93 Update OBC software when replacing HV wiring harness for charging socket

93 23 03 2070110/1 April 25, 2023.

Model(s)	Year	VIN Range	Vehicle-Specific Equipment
e-tron quattro	2019	All	Not Applicable
e-tron Sportback quattro	2020

Figure 1. High-voltage wiring harness for charging socket.

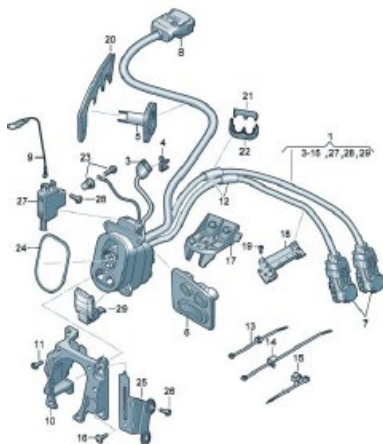
The High Voltage Wiring Harness for the charging socket UX4 or UX5 is replaced as part of any repair work (Figure 1).

The charging socket was modified in production.

From 06/15/2020, only the new-generation high-voltage wiring harness for the charging socket is fitted in production vehicles.

If the high-voltage wiring harness for the charging socket is replaced as listed in Table 1.2, an SVM code will need to be performed *and a replacement test plan performed*.
